# DPLCA Issues in D1.0

Contribution to 802.3da Task Force

March 13, 2024

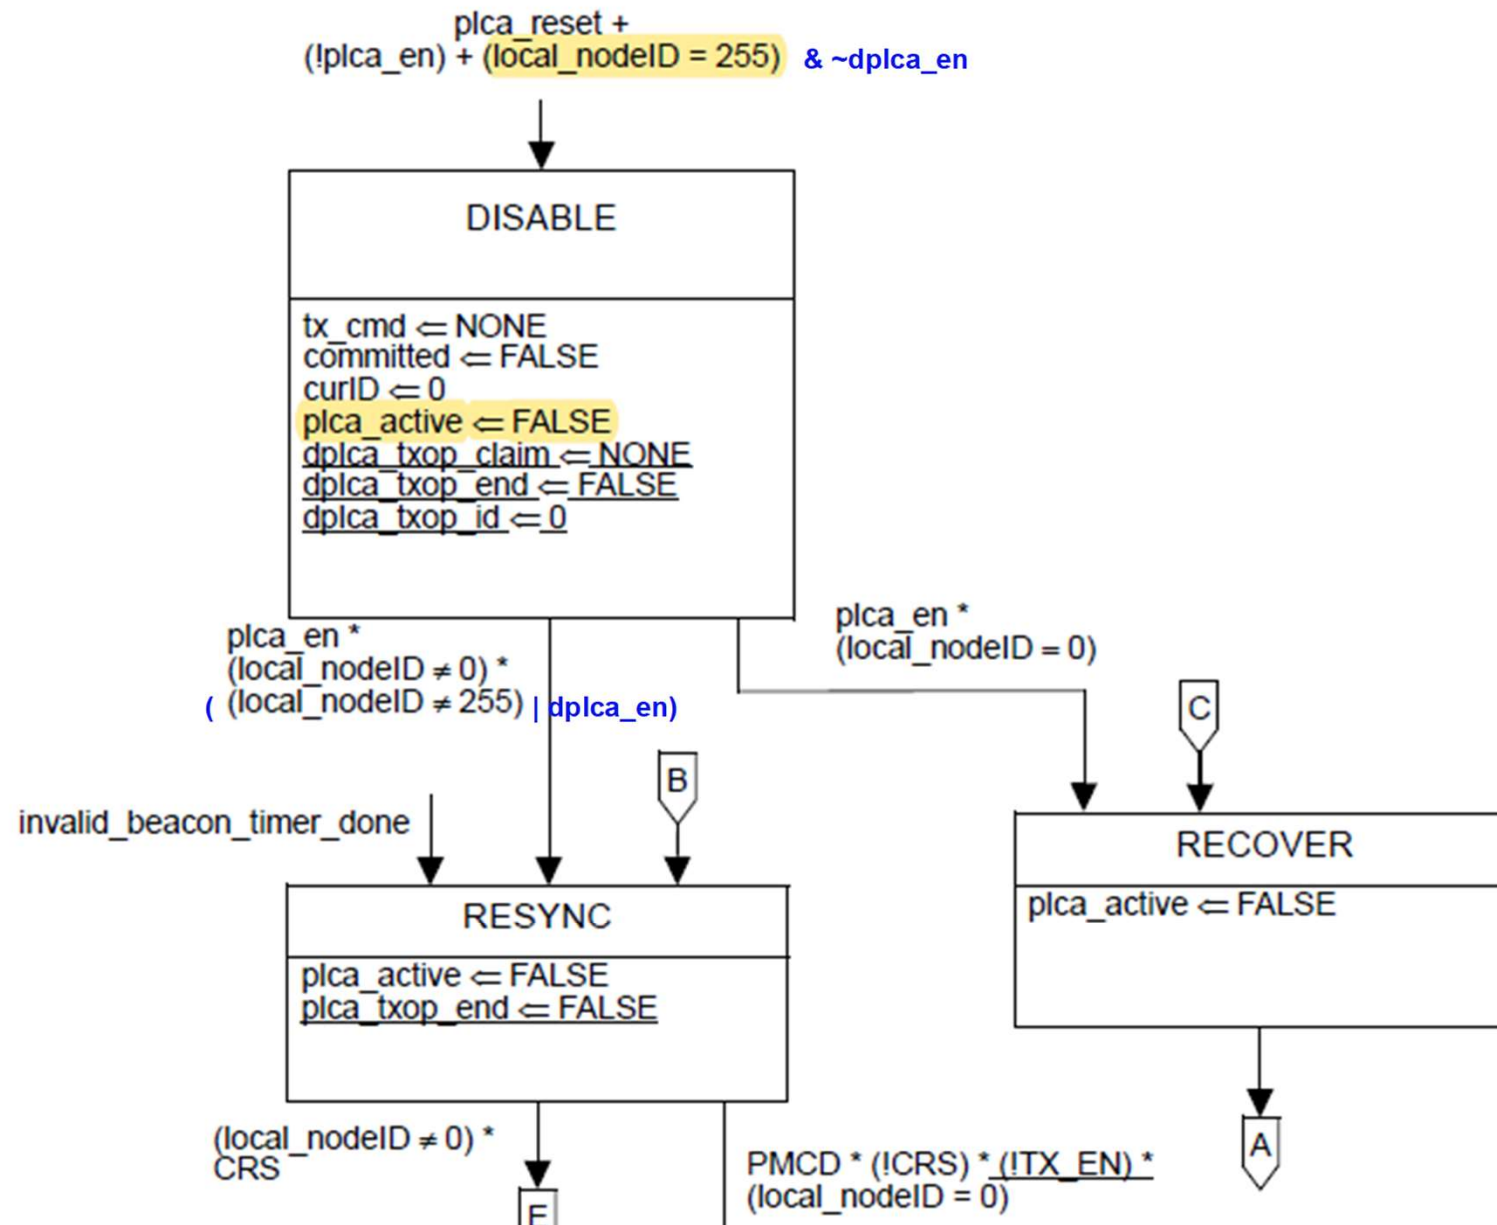
- Issue: DPLCA Control will lockup in **WAIT\_BEACON**
  - When **coordinator\_role\_allowed=FALSE**, see slide 4
  - **WAIT\_BEACON: local\_nodeID <= 255**
    - > PLCA Control forced to **DISABLE**: **plca\_active<=FALSE**
    - > PLCA Status forced to **INACTIVE**: **plca\_status<=FAIL**
    - > DPLCA Control cycles **DISABLED** / **WAIT\_BEACON** indefinitely waiting for **plca\_status=OK**
- Proposal:
  - use **dplca\_en** to prevent forcing PLCA Control to **DISABLE** when **local\_nodeID = 255**
  - use **dplca\_en** to exit **DISABLE** to **RESYNC** when **local\_nodeID ≠ 0**
  - see slide 5

Change Figure 148-3 and Figure 148-4 as shown:

Figure 148-3—PLCA Control state diagram, part a

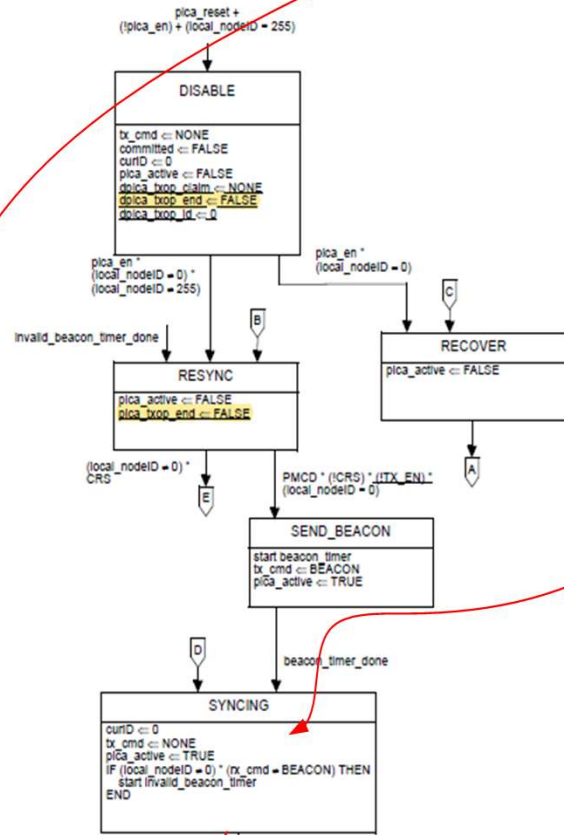
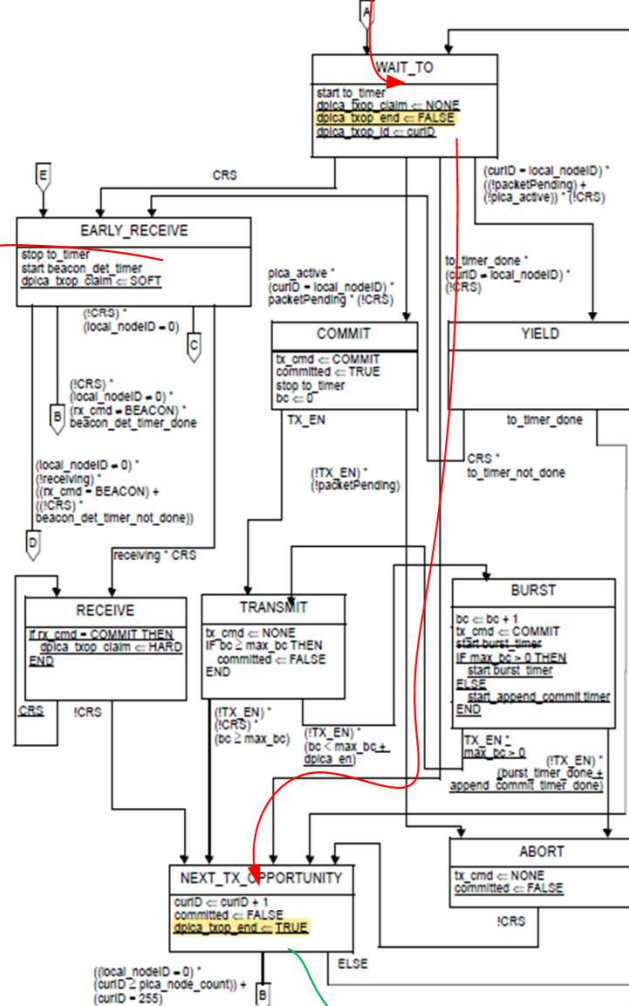
- Intent: transition from **COORDINATOR** to **LEARNING** upon BEACON detection from another node – see slide 9 state diagram
  - beruto\_3da\_01\_031021.pdf slide 17
- Issue: BEACON doesn't trigger a transition
  - for condition:  $dplca\_txop\_table\_upd * (hard\_claiming(0) + rx\_cmd = BEACON)$ 
    - variables  $dplca\_txop\_table\_upd$ ,  $rx\_cmd = BEACON$  aren't true simultaneously
    - sequence on slide 7, timing diagram on slide 8
- Proposal: modify D-PLCA Control as shown in slide 9
  - Allow transition to **LEARNING** upon BEACON detection

Change Figure 148-3 and Figure 148-4 as shown:

Figure 148-9—D-PLCA Aging State Diagram

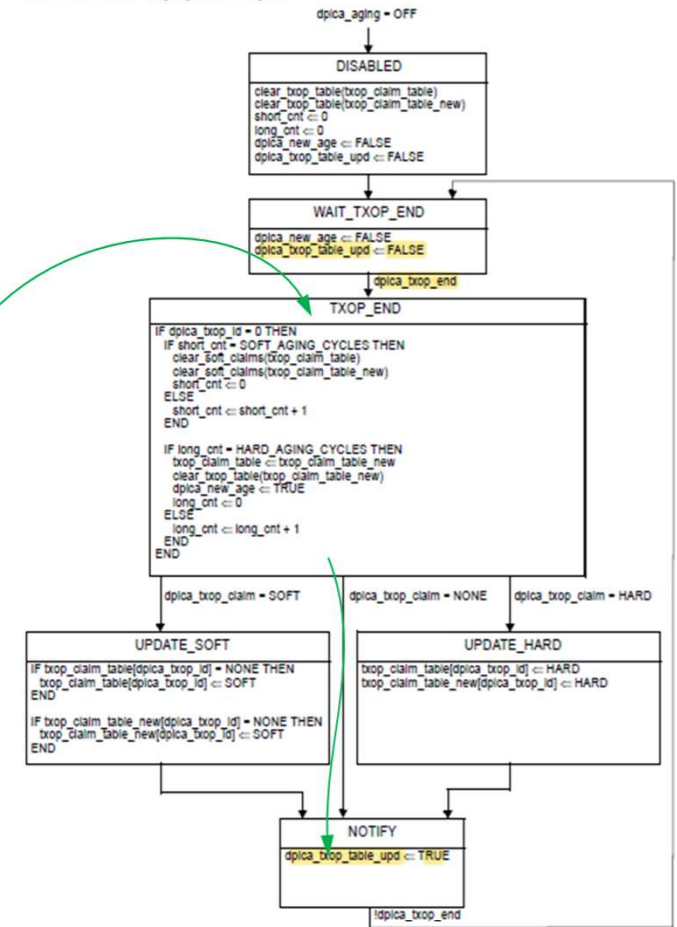
## Interaction between PLCA Control and D-PLCA Aging when rx\_cmd=BEACON

Figure 148-8—D-PLCA Control State Diagram  
 $((dplca\_txop\_id=0) * (dplca\_txop\_node\_count \leq local\_nodeID))$

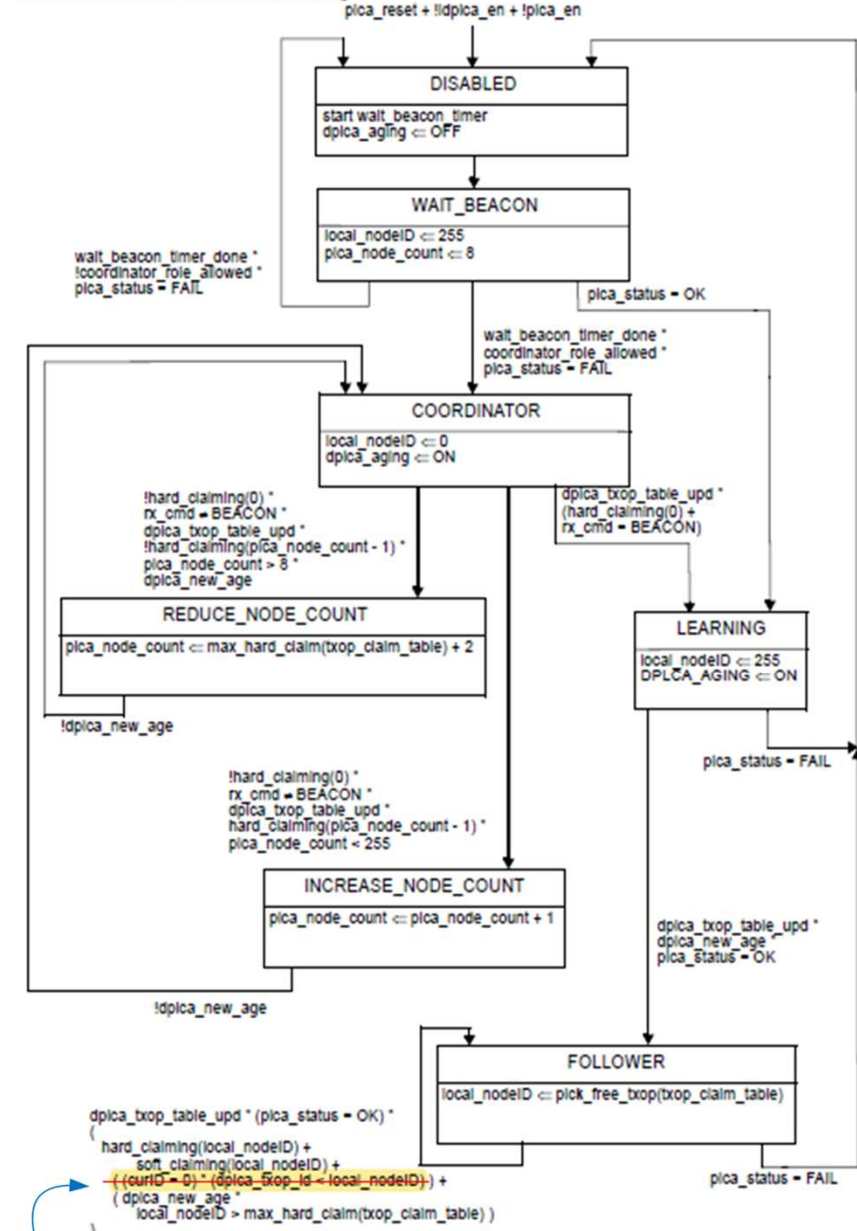
- Intent: pick a new `local_nodeID` if ID is greater than `plca_node_count`
- Issue: condition doesn't trigger a new pick
  - for condition: `dplca_txop_table_upd * (plca_status = OK) * ( ...+( (curID = 0) * (dplca_txop_id < local_nodeID) + ...)`
    - `(curID = 0) * (dplca_txop_id < local_nodeID)` isn't aligned to `dplca_txop_table_upd`
    - timing diagram on slide 11
- Proposal: modify PLCA control and DPLCA control as shown in slide 12
  - In `SYNCING` latch the value of `dplca_txop_id` for use in `FOLLOWER`
    - to new variable `dplca_txop_node_count` in PLCA Control and D-PLCA Control
  - In `FOLLOWER` to `FOLLOWER` transition
    - replace `(curID = 0) * (dplca_txop_id < local_nodeID)`
    - with `(dplca_txop_id = 0)*(dplca_txop_node_count ≤ local_nodeID)`

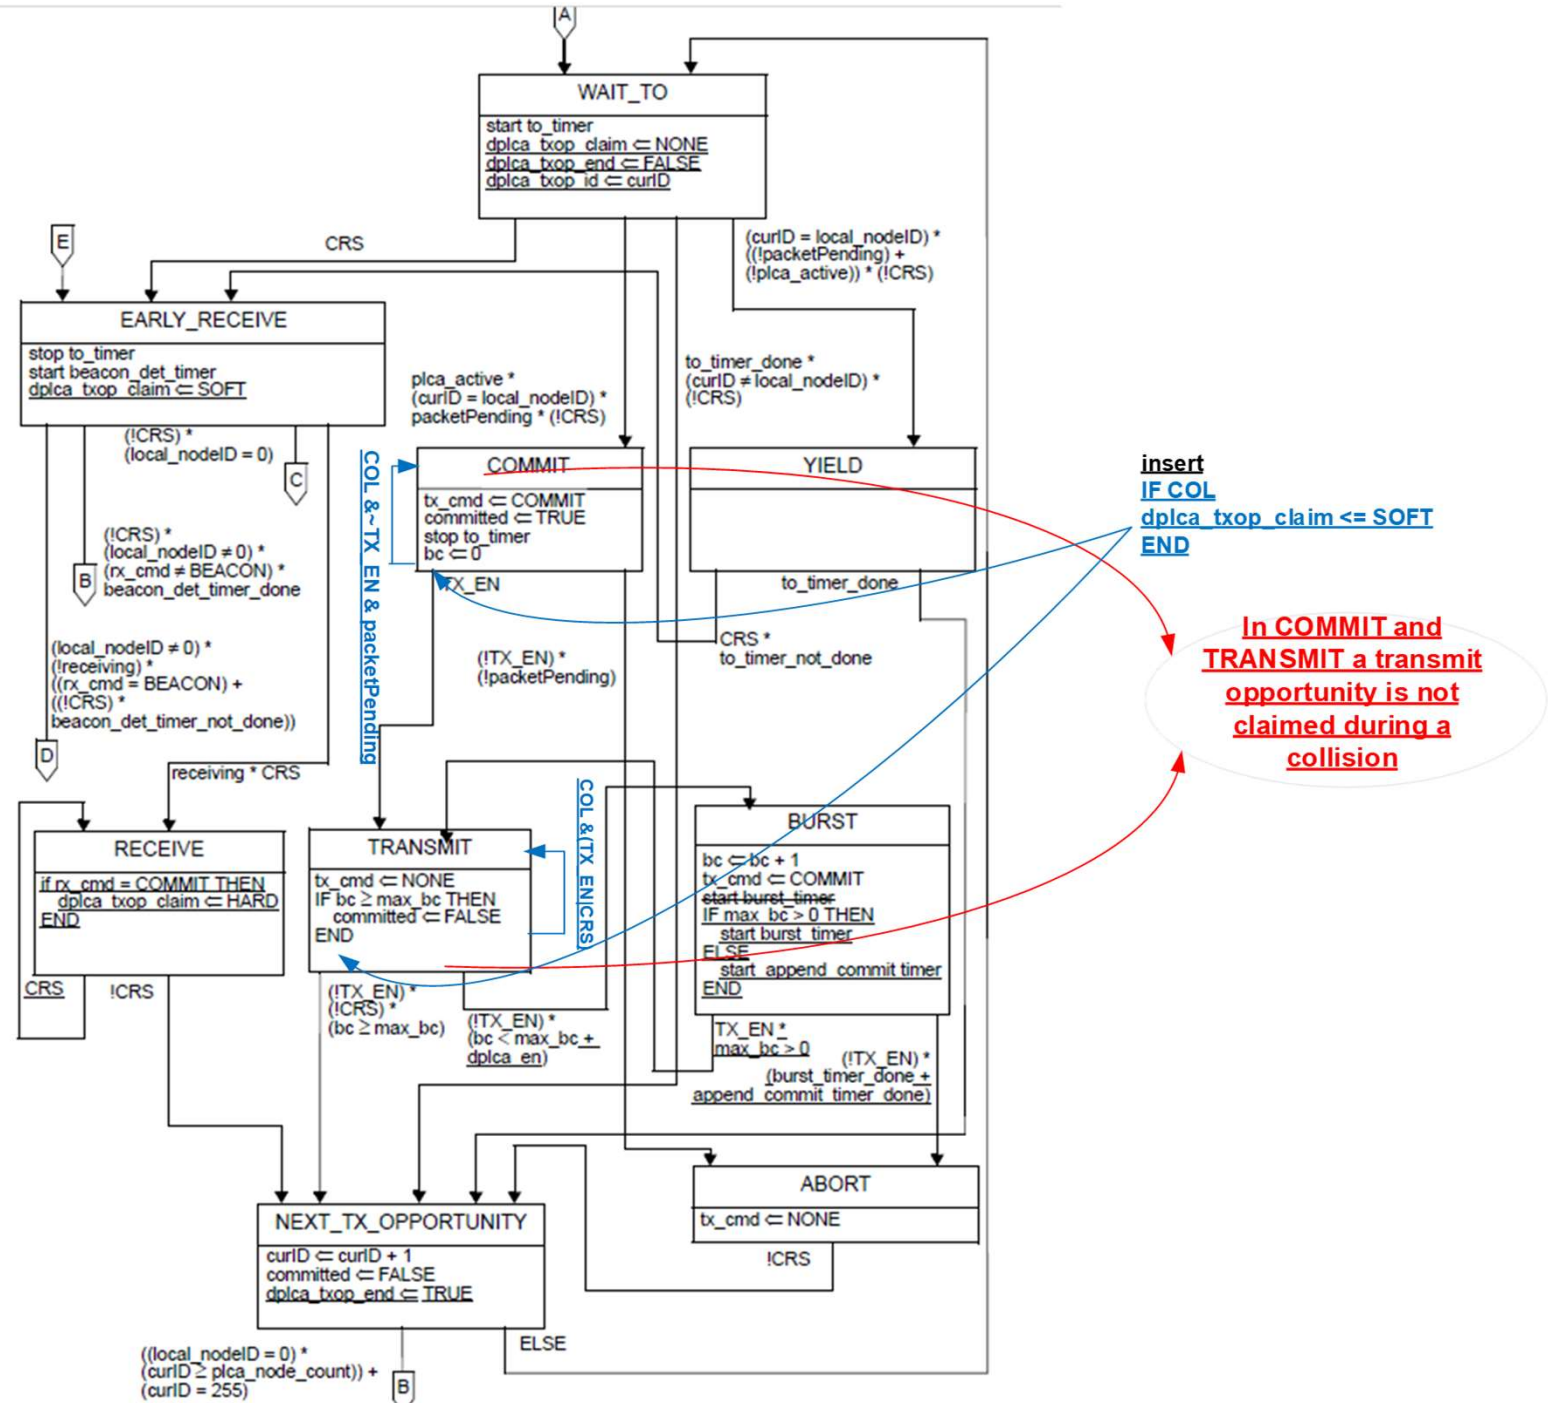
- Issue: Coordinator lockup can happen when two nodes send the BEACON at the same time
  - PLCA is not able to register activity from other nodes while transmitting BEACON
- Proposal: needs further study

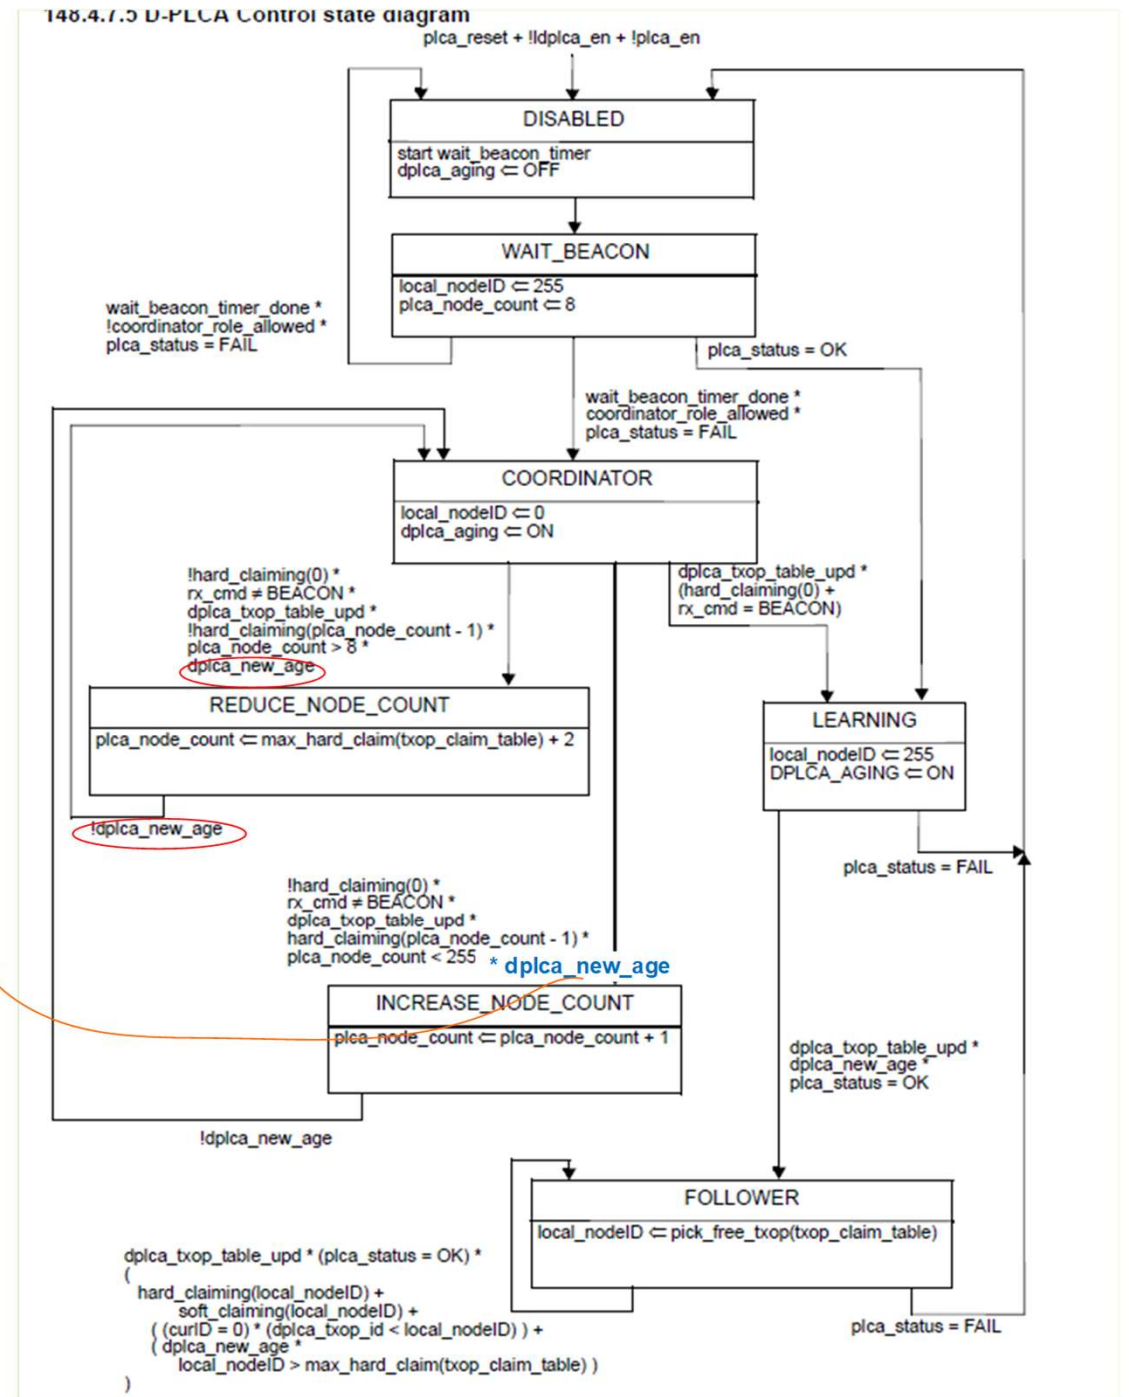
- Issue: COORDINATOR to INCREASE\_NODE\_COUNT transition appears to be missing condition of `dplca_new_age` used on alternate paths
- Proposal: add condition `* dplca_new_age`
